R22 SERVICE BULLETIN SB-120C
(supersedes R22 Service Bulletin SB-120B)

DATE: 22 December 2022 **REV C:** 28 January 2025

SUBJECT: Tail Rotor Blade Inspection and Replacement

EFFECTIVITY: P/N A029-2 tail rotor blade S/Ns 11279 and prior (A029-2 REV U and prior). Affected blades were factory-installed on R22 Helicopter S/Ns 4873 and prior.

SPECIAL TAIL ROTOR TIP PREFLIGHT INSPECTION

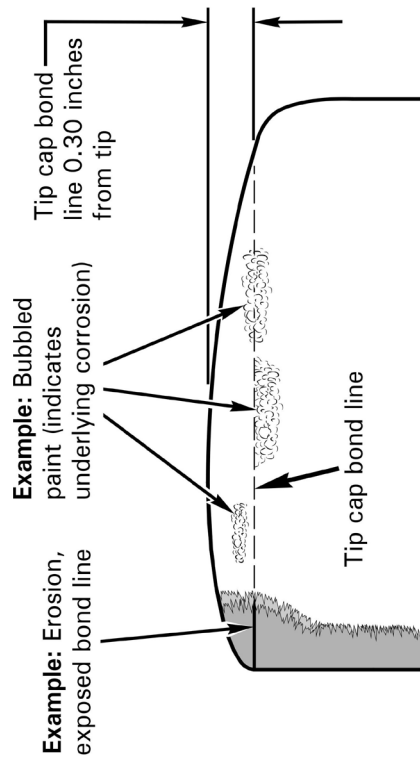
Refer to Figure below.

To be performed before the first flight of each day. May be performed by pilot or mechanic. Conduct visual inspection of tail rotor tip area. If bubbled paint or other evidence of corrosion is observed at or adjacent to tip cap bond line or if any portion of tip cap bond line is exposed, do not fly helicopter. Comply with latest revision of R22 SL-93 prior to further flight.
